GROUP 54

CHASSIS ELECTRICAL

OUTLINE OF CHANGES

HEADLAMP AND FRONT TURN-SIGNAL LAMP ASSEMBLY

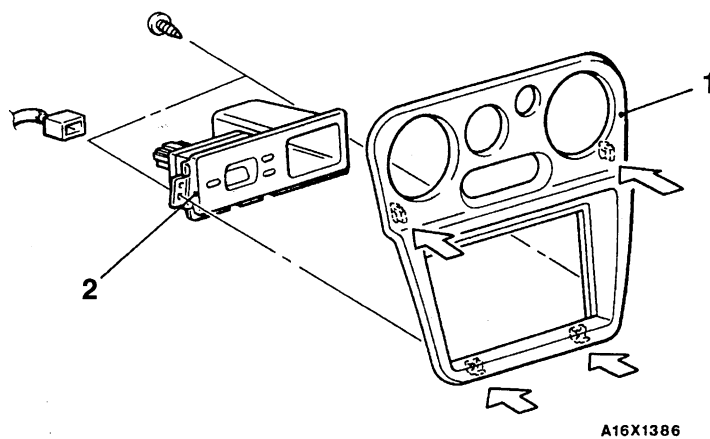
- The inspections of lighting switch, dimmer/passing switch and turn-signal lamp switch have been changed to correspond to the change of the column switch.
- The removal and installation procedures have been established to correspond to the addition of the clock to the vehicle without radio.

COLUMN SWITCH CONTINUITY CHECK

Switch position		Connector A-terminal No.				Connector B-terminal No.				
		1	2	3	4	6	3	5	6	7
LIGHTING SWITCH	OFF									
	TAIL									
	HEAD									
DIMMER/ PASSING SWITCH	LOWER									
	UPPER									
	PASSING									
TURN-SIGNAL LAMP SWITCH	RH									
	OFF									
	LH

1. *1 indicates continuity when the dimmer switch is in the lower position.
2. *2 indicates continuity when the dimmer switch is in the upper position.
